Access Compliance Report

Public Rights-of-Way

(Curb Ramps)

Intersection ID: 44850	Main Street: STEELE_CREEK_RD	Cross Street: SHOPTON_RD_WEST	Location: NW
ADA ID: AD9D4BE0538A	Ramp Type: Para	Initial Pass/Fail: Fail	Overall Compliance: No
Severity Score: 26.25			
Codes/Mitigation Info/Possible Solution		Field Measurements/Component Compliance

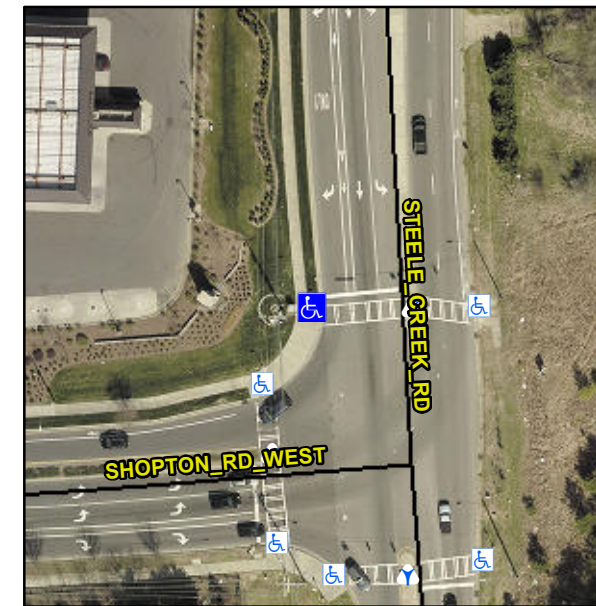
LT RP < 5%

PROW/ADA:

R304.5.3, R304.3.2

Possible Solutions:

Remove & Replace Entire Ramp.
